TOWN OF HUDSON

PUBLIC MEETING TOWN OF HUDSON, NH FEBRUARY 12, 2020

MINUTES/DECISIONS OF THE PLANNING BOARD

DATE: DECEMBER 6, 2019 SCALE: 1"=100'
PROJECT NO: 19-0408-1 SHEET 1 OF 31

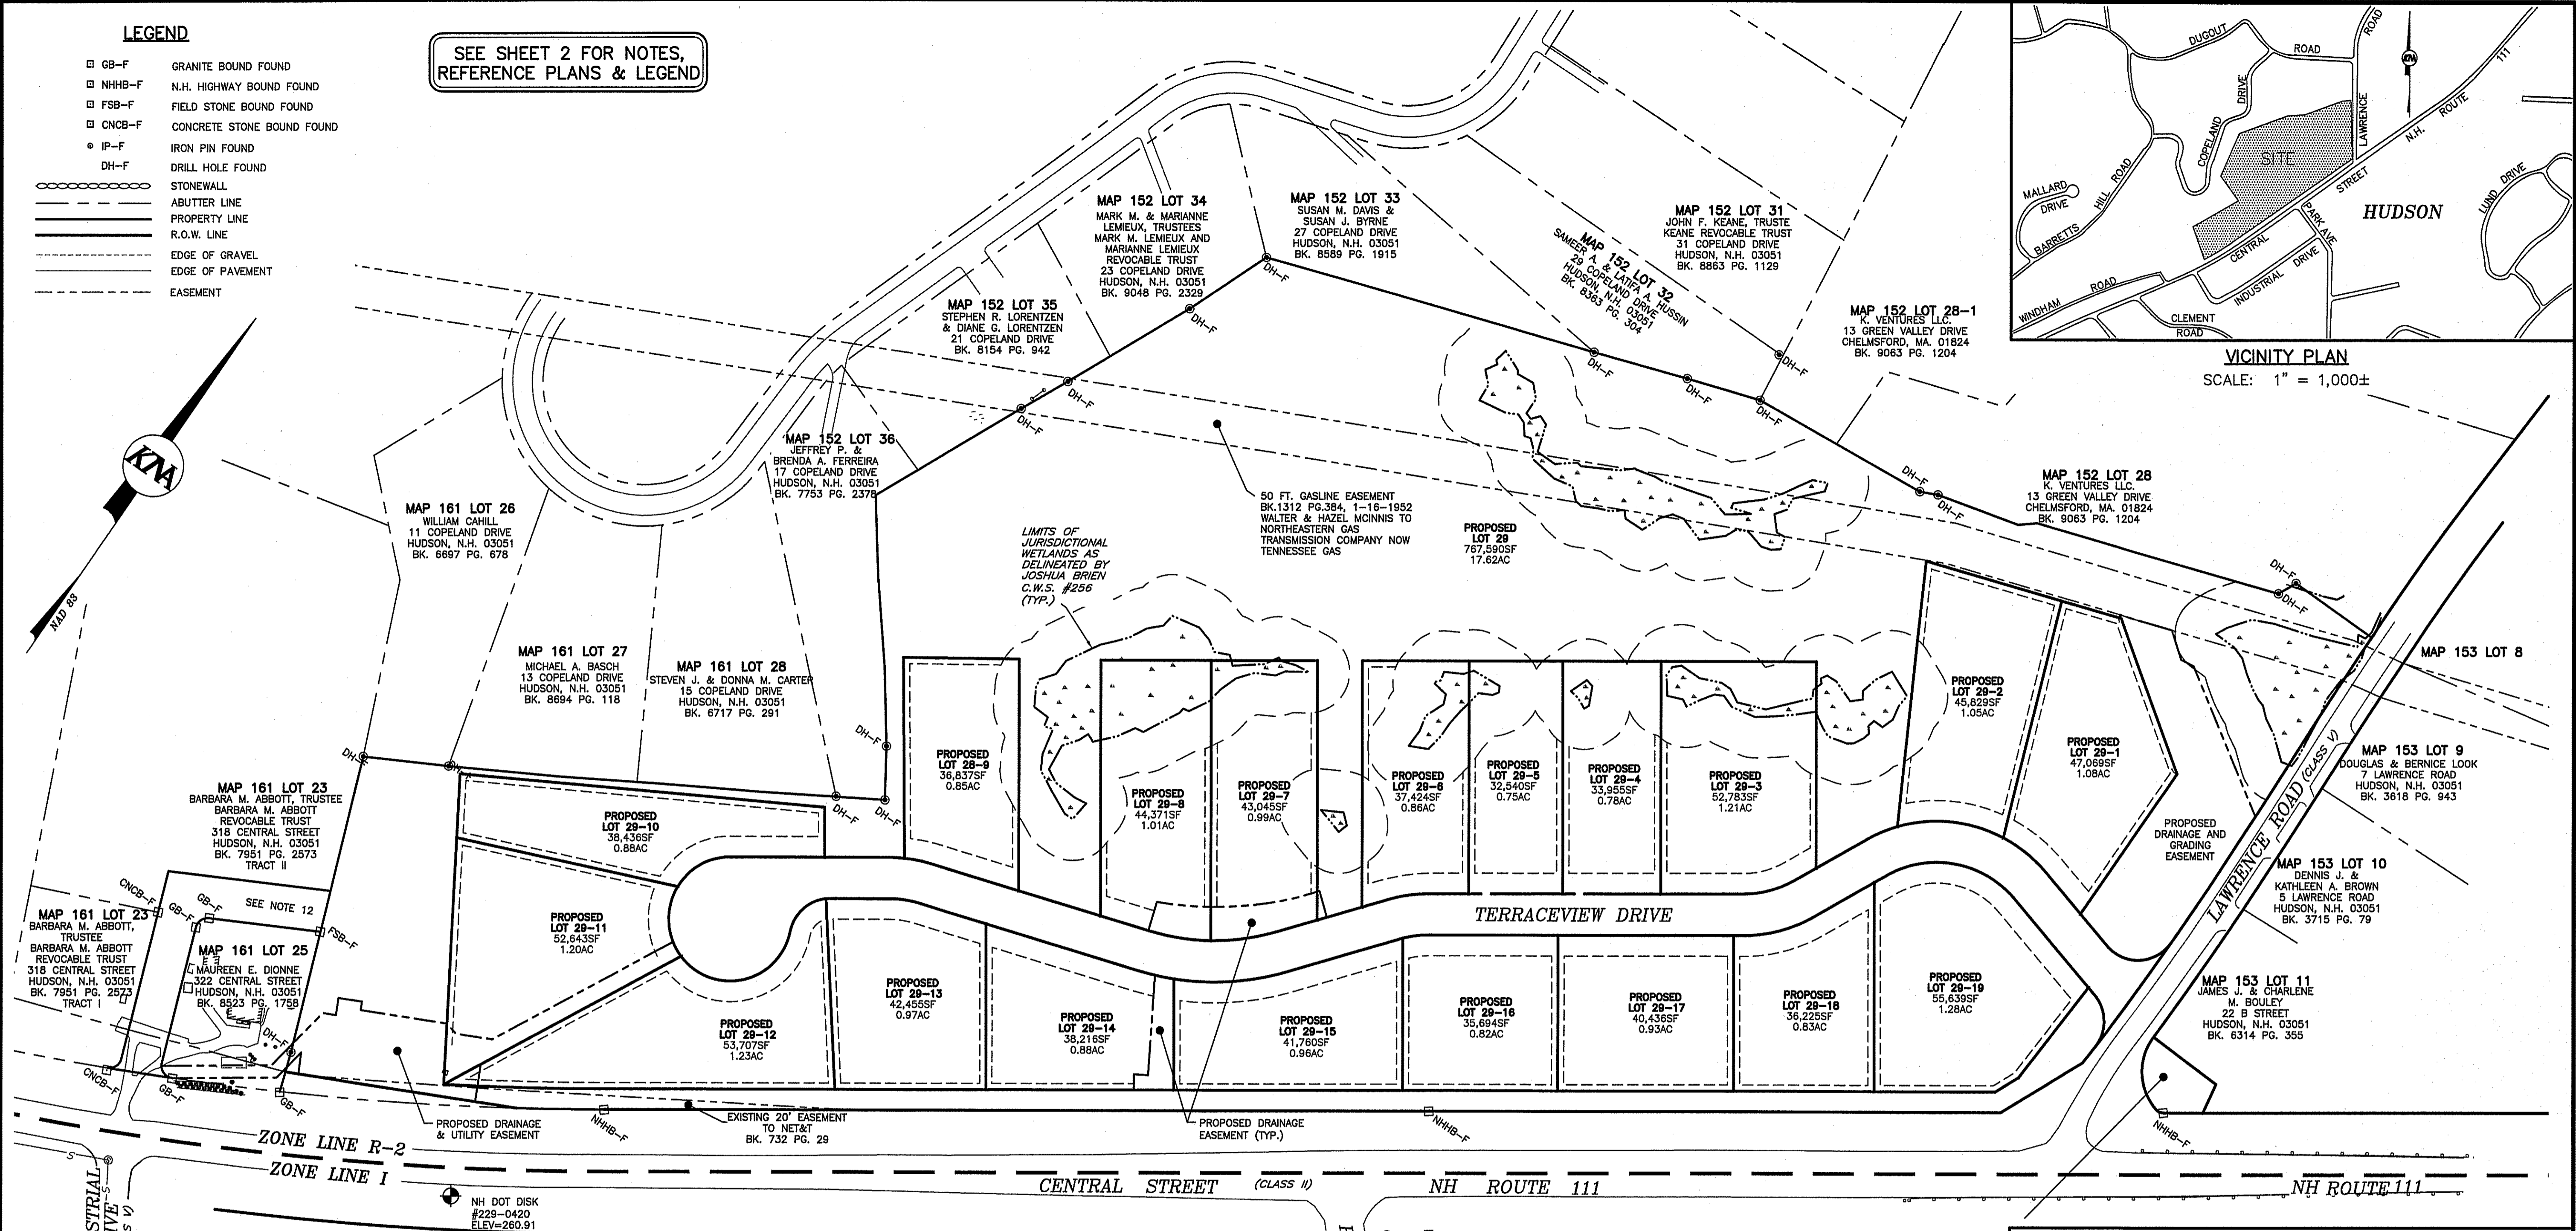
- e. HR 276-11.1.B.(16). The applicant has not shown the locations of all driveways and parking areas within 200 feet of the tract.
All driveways and parking areas within 200 feet of the tract are now shown sheet 1 titled "MASTER SUBDIVISION PLAN".

DATE: DECEMBER 6, 2019 SCALE: NONE
PROJECT NO: 19-0408-1 SHEET 2 OF 31

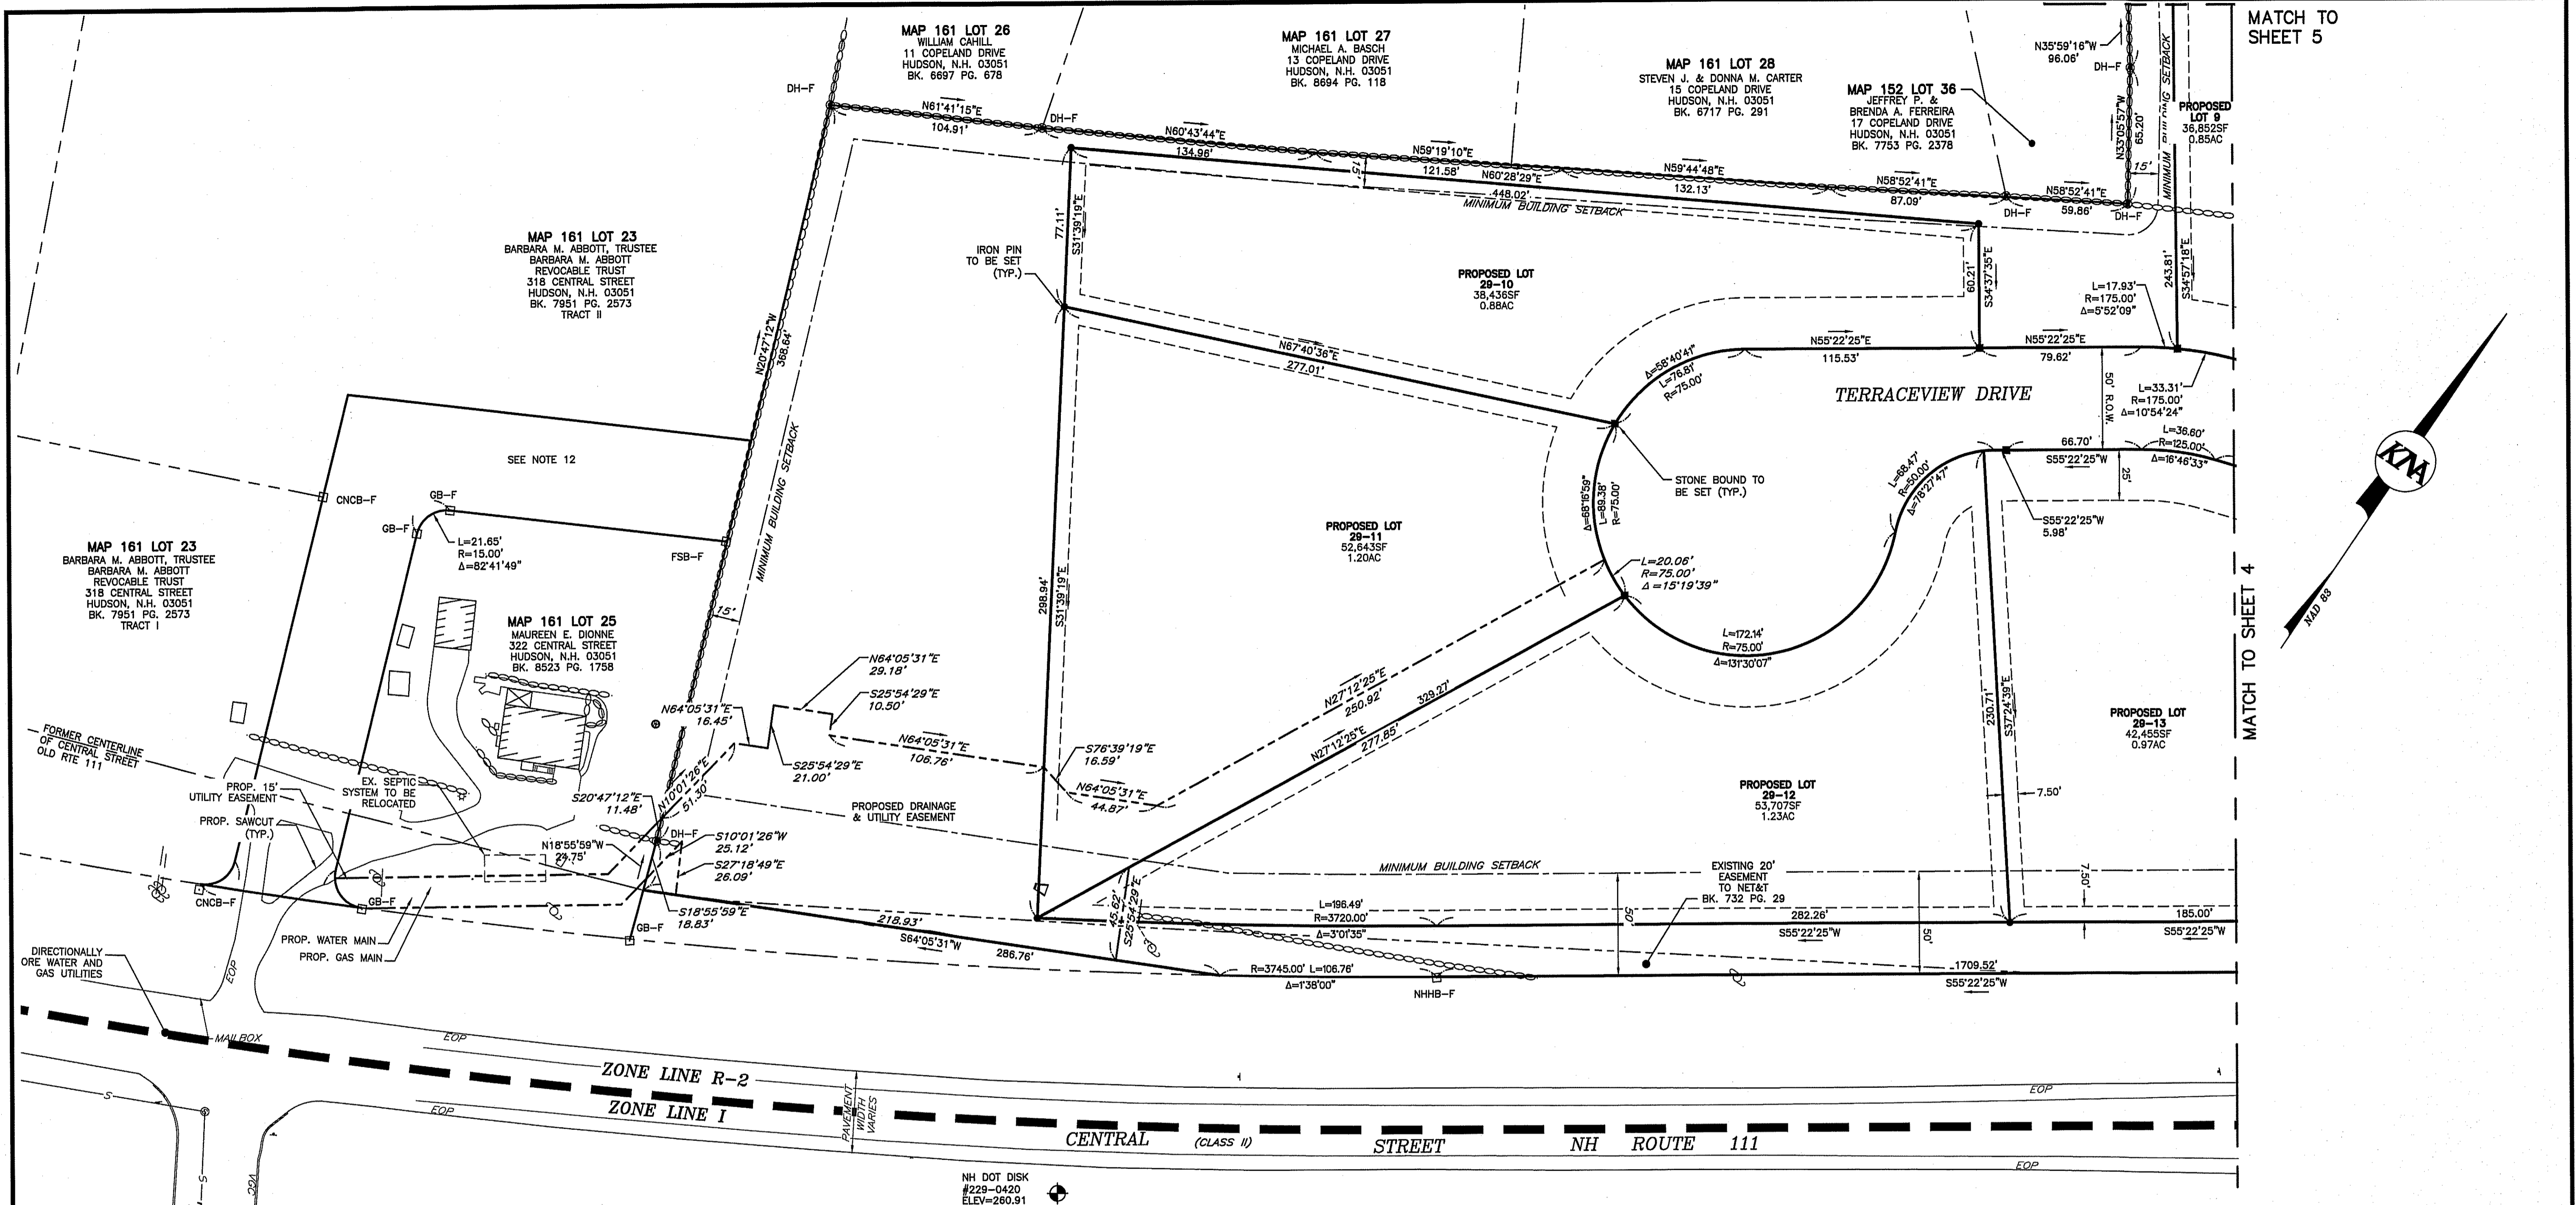
- a. The applicant has included notes #14 and #21 on sheet #2 that appear to contradict each other. The applicant should correct these notes as appropriate.

- a. The applicant has included notes #14 and #21 on sheet #2 that appear to contradict each other. The applicant should correct these notes as appropriate.

Note #14 has been removed from sheet #2.

DATE: DECEMBER 6, 2019 SCALE: 1" = 40'
 PROJECT NO: 19-0408-1 SHEET 13 OF 31

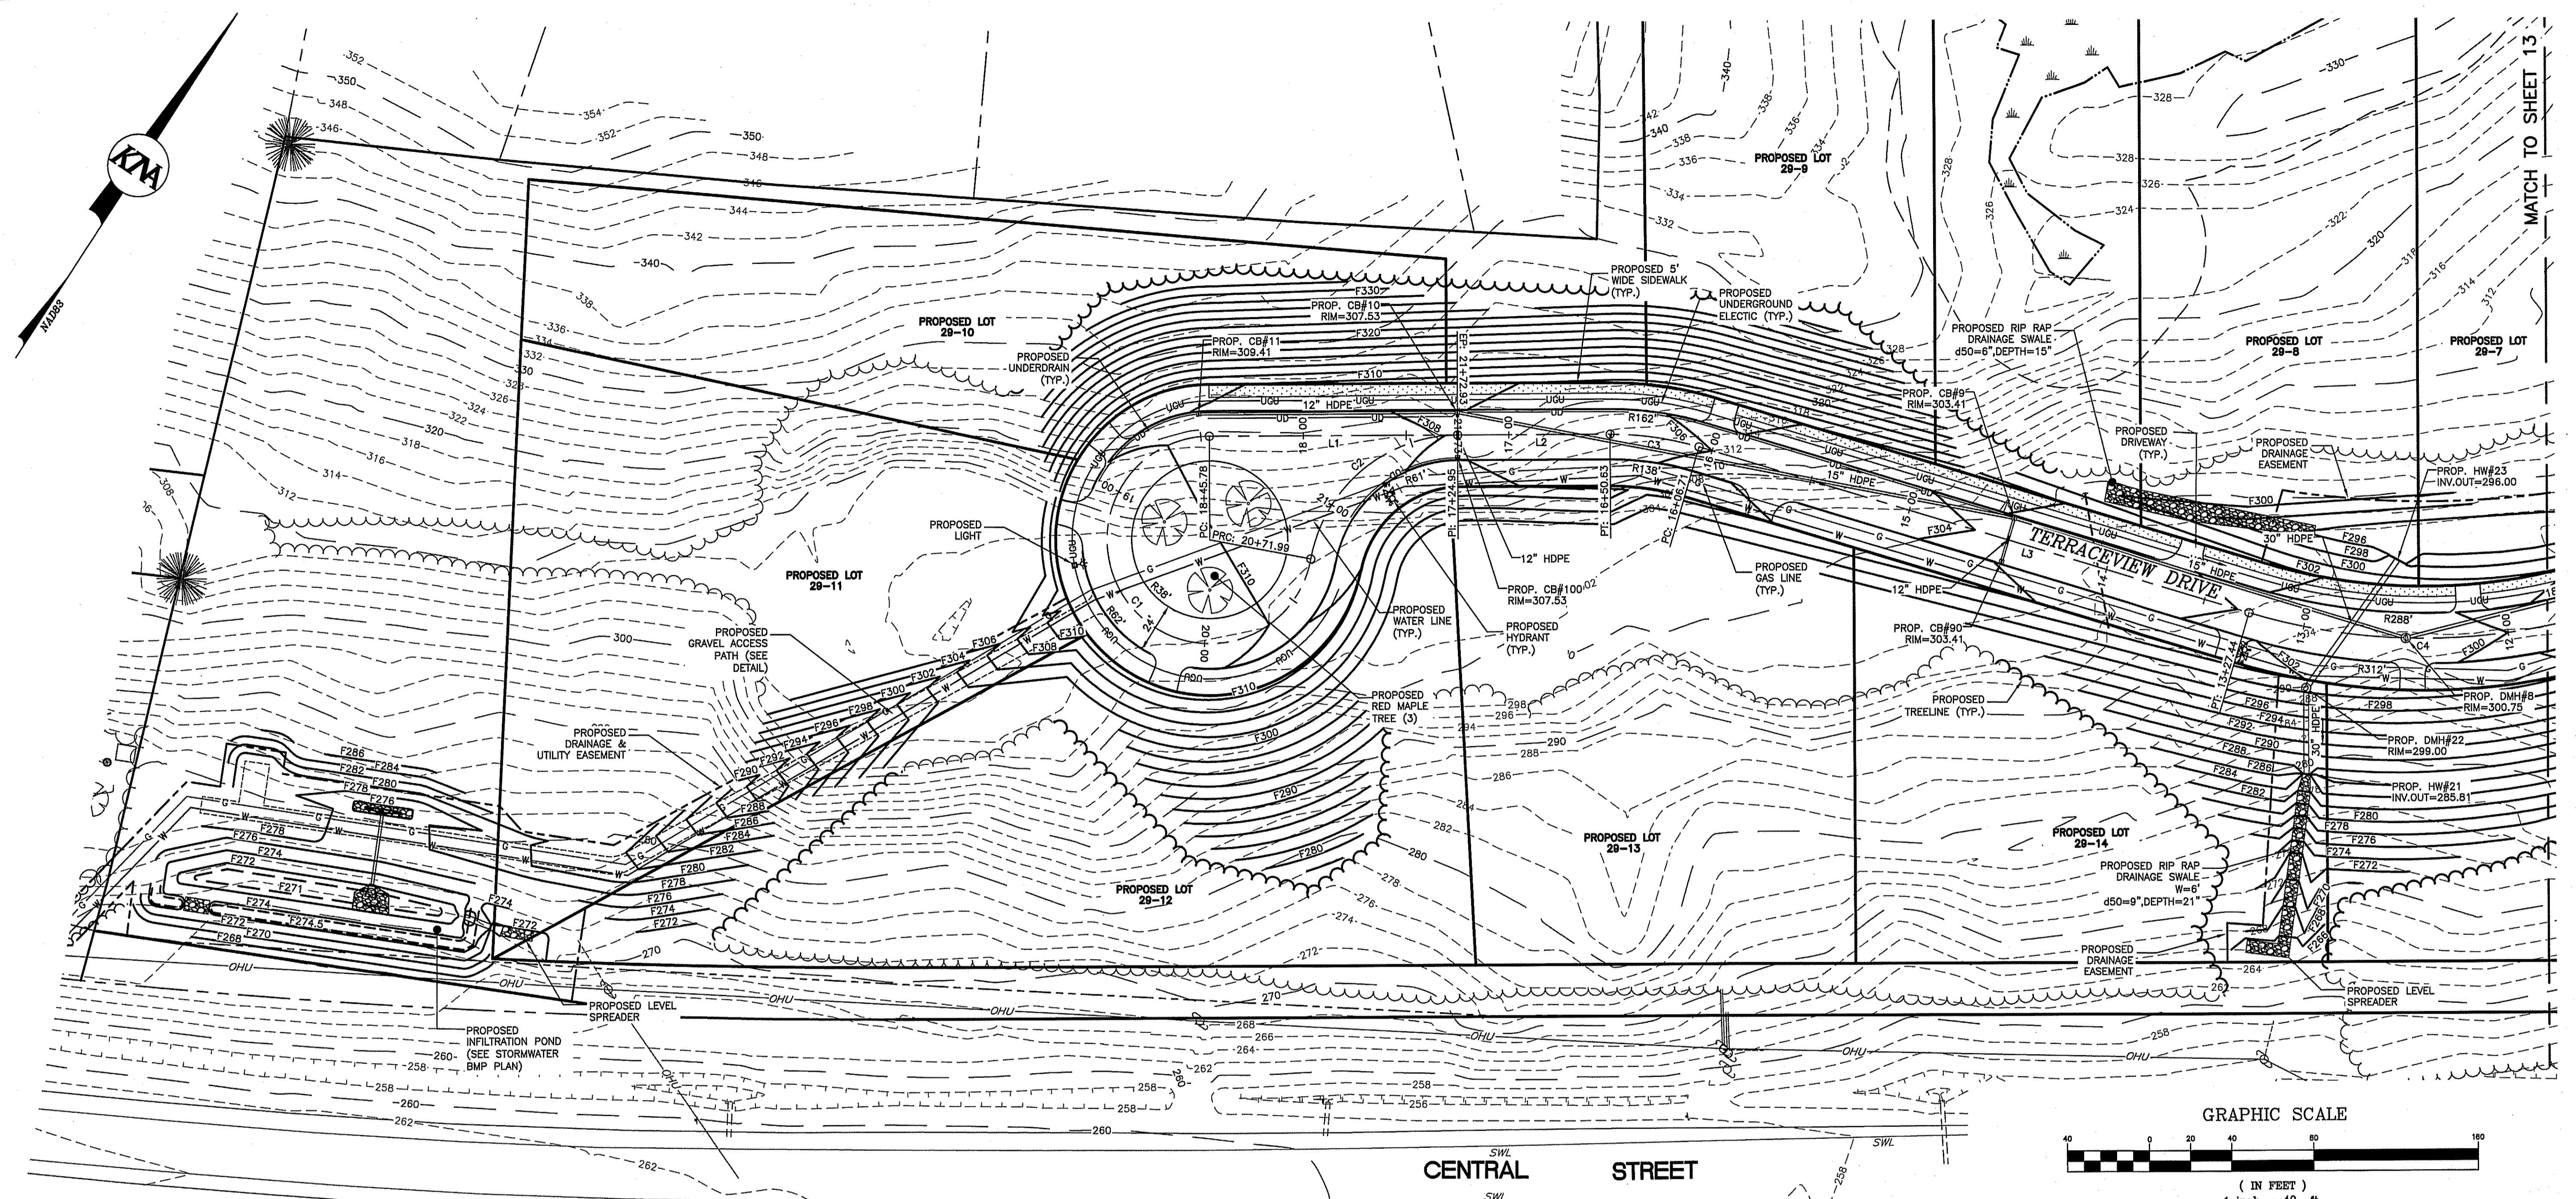
There is now a note located within the Roadway Plan, sheet 13, located where there may be obstructions to sight line. The note states "CUT & CLEAR ANY IMPEDIMENTS TO SIGHT DISTANCE. COORDINATE WITH THE TOWN OF HUDSON FOR WORK WITHIN THE R.O.W."
